# UNITED STATES PATENT AND TRADEMARK OFFICE

APPLICATION NO.	FILING DATE	FIRST NAMED INVENTOR	ATTORNEY DOCKET NO.	CONFIRMATION NO.
10/680,358	10/07/2003	Frank J. Schwab	4002-3426/PC819.00	5654

## Office Action Summary

Figure 1

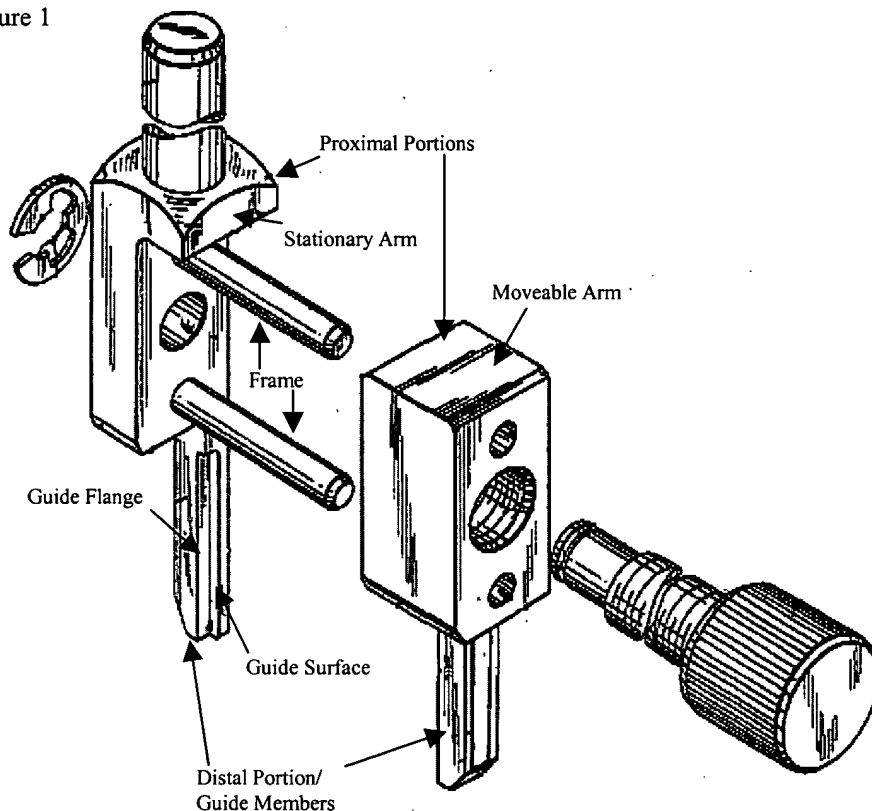
Regarding claims 1, 17-20, and 37-40, Weissman discloses a device (see Figure 1 below) comprising a proximal portion and a distal portion. The proximal portion further includes a frame, a stationary arm, and a moveable arm couple to the stationary arm. The distal portion further includes first and second guide members that extend distally from the stationary and moveable arms. The guide members are moveable relative to each other by moving the moveable arm relative to the stationary arm. Each guide member includes a guide surface extending from the proximal end to the distal end of each guide member and are oriented towards each other and are generally parallel. Each guide member further includes a guide flange extending along either the first or second side of the guide member. The guide flange projecting from one of the guide surfaces towards

the guide surface of the other guide member. Regarding claims 9 and 26, Weissman discloses a device wherein the guide surfaces are planar.
